CAA Operational Assessment

Title of Airspace Change Proposal (ACP)	Enabling Remotely Piloted Aircraft Operations at RAF Fairford - HALE
Change sponsor	Ministry of Defence (MoD)
Project reference	ACP-2021-078
Account Manager	██████████
Case study commencement date	13 Dec 2023
Case study report as at	24 Jan 2024

Figure 3 – Proposed Amendment of EGD218 C & D (Upper Altitude to FL660)

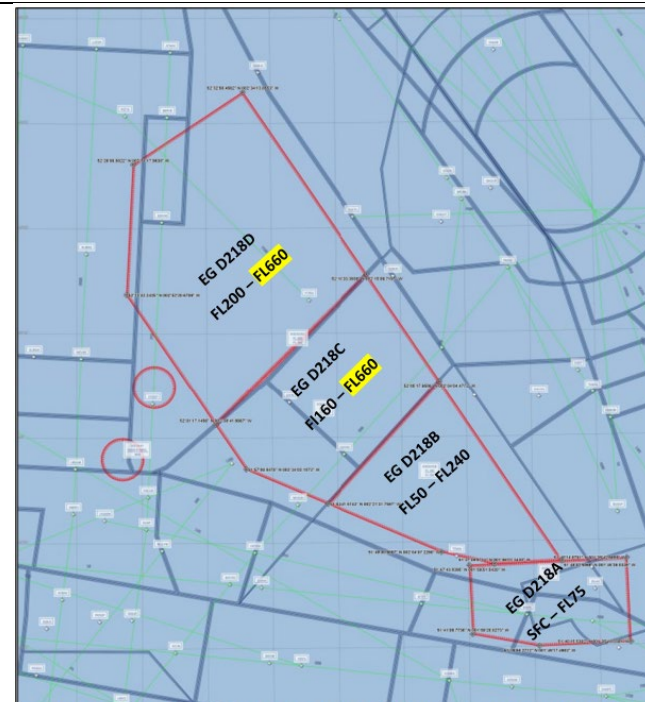
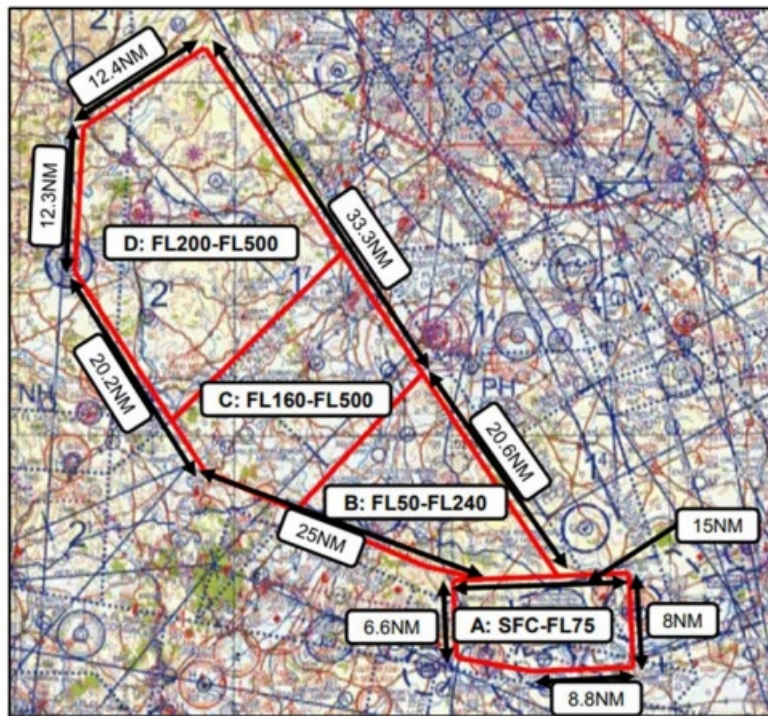
The Operational Arrangement is not in place and in order to future proof the airspace for other assets to utilise, consideration should be given to raising the top level of EDG218 C and EDG218 D to FL660. Doing so would allow US HALE RPA to operate

<p>in accordance with CAP 722 and then proceed to their operational airspace as agreed in the Operational Agreement or future more capable US HALE RPA to operate under due regard (above FL660) as they will be outside the London and Scottish FIRs/UIRs.</p> <p>Following internal CAA discussions it is likely that in order for US HALE RPA to enter and exit the London and Scottish FIRs/UIRs they will need to be segregated as per CAP 722.</p> <p>Technical Amendment: Following a request by the CAA to the sponsor for clarification on onwards operations the sponsor was asked to consider a technical amendment to the airspace design. That amendment sees the upper level of the DA complex (segment C and D) rise to FL660 rather than FL500 as stated in the final submission.</p> <p><u>Recommended draft condition 1</u></p> <p>It is recommended that a condition is placed on the approval of this ACP such that the airspace may not be activated until suitable airspace arrangements are approved by the CAA to facilitate entry and exit routes into and out of the DAs contained within this ACP.</p> <p>And,</p> <p><u>Recommendation 1</u></p> <p>It is recommended that a condition is placed on the approval of this ACP such that the airspace may not be activated until suitable airspace arrangements are approved by the CAA to facilitate entry and exit routes into and out of the DAs contained within this ACP.</p>

Technical Amendment: Following a request by the CAA to the sponsor for clarification on onwards operations the sponsor was asked to consider a technical amendment to the airspace design. That amendment sees the upper level of the DA complex (segment C and D) rise to FL660 rather than FL500 as stated in the final submission.
